**IN THE MATTER of Drury Metropolitan Centre Consolidated Stages
1 and 2 (the Project)**

JOINT WITNESS STATEMENT (JWS) IN RELATION TO:

Topic: Transportation

Date 3 October 2025

Additional Info: Road 13 / Road 25 vehicle tracking

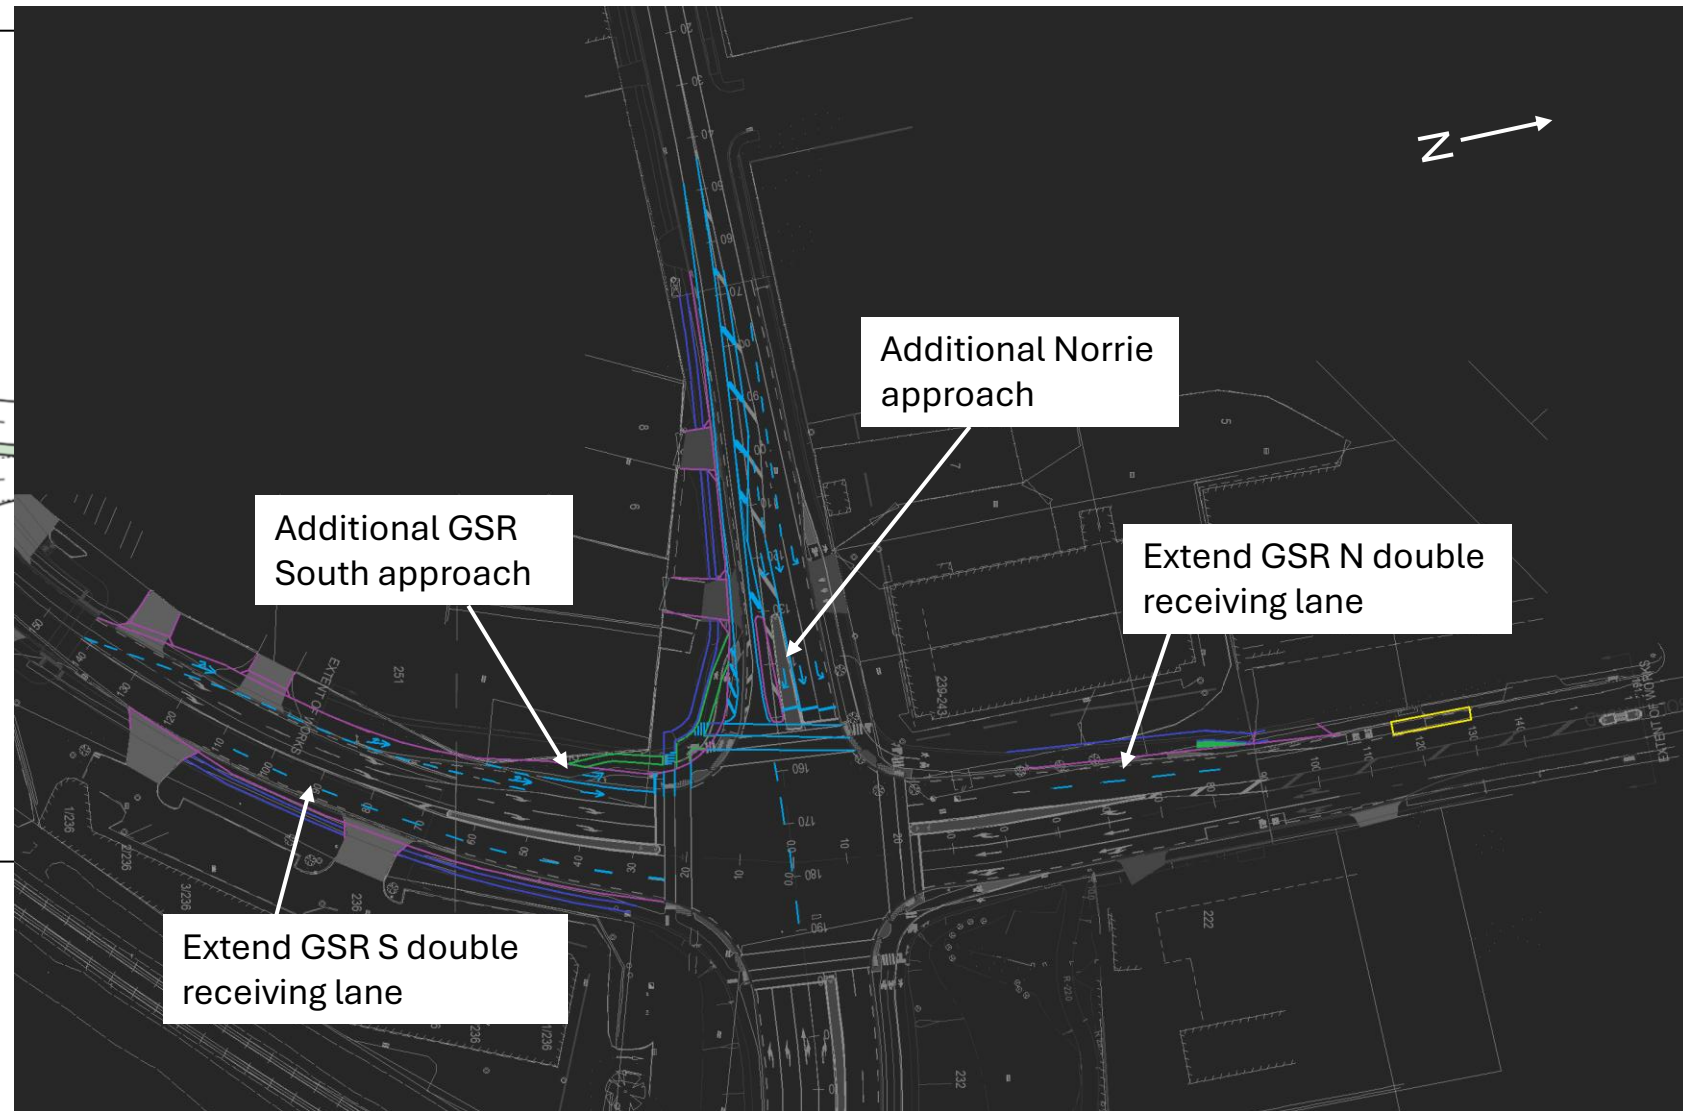
3. Issue: No provision has been made on building plans in respect of waste management and collection, with this matter to be deferred to the future provision of a Waste Management Plan.

Can waste management appropriately be provided for by the proposed development (individual buildings) and the respective loading arrangements (ECP: Draft wording for a WMP has been provided but no corresponding plans details at this stage).

- 3.16.1 MC and LH suggest that the conditions be expanded to provide a waste management and loading management plan.
- 3.16.2 MW advised that the level of detail in terms of waste storage has not been finalised at this stage and it is proposed to be addressed through conditions. She agrees that the provision of appropriate vehicle tracking for waste management and heavy vehicles and loading should be added to the conditions.
- 3.16.3 DH will circulate the results of vehicle tracking for articulated truck movements at Road 25 / Road 13. (Attachment A p. 34)

Changes to NZTA design to achieve full 3,800vph without SH1DC

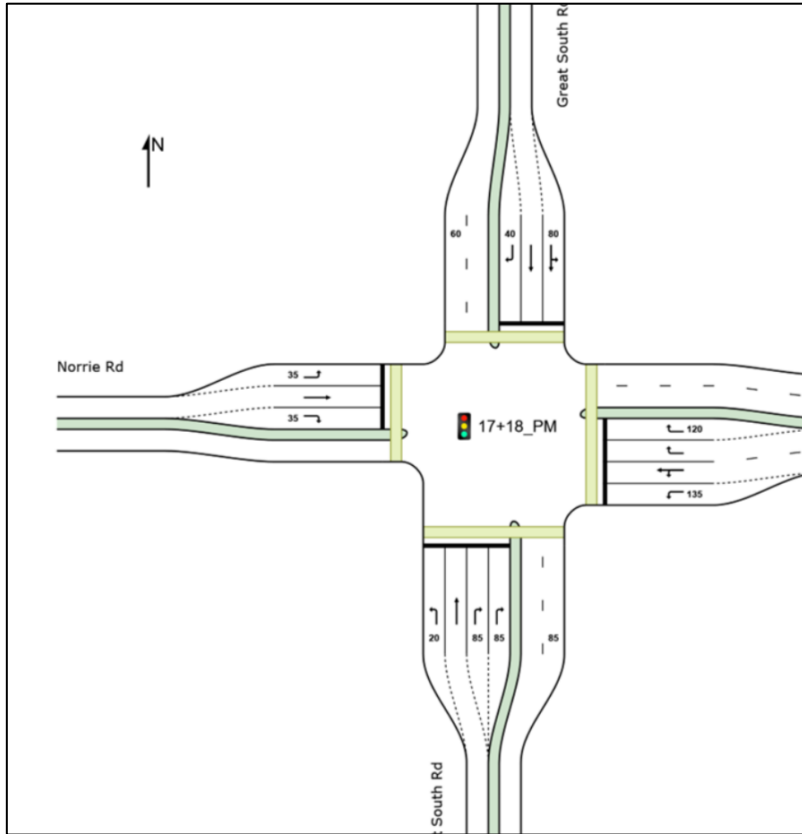
- 3.6.5 PS noted that the applicant’s expert has only modelled the Waihoehoe Road / GSR intersection with the Plan Change layout and not with the NZTA/AT layout with the 3,800vph threshold. For the NZTA/AT layout, the applicant’s expert has only modelled 2,700vph threshold and with any more traffic than this, the average queue lengths extend back through the nearest intersections and are unacceptable in terms of the network criteria previously agreed. This will have significant congestion related effects not just on people travelling to and from the Metro Centre but also residents of the surrounding area, existing traffic on GSR, and the feeder bus service to the station serving areas north and west of the railway line.

- 3.1.6 The proposed solution is to introduce a new condition requiring the NZTA/AT intersection (assuming it is built based on the current design) to be upgraded to include additional and longer approach lanes in accordance with the attached diagram (Attachment A – pp. 35 - 36) after the threshold of 2,700vph has been met. This will allow the full development up to 3,800vph.
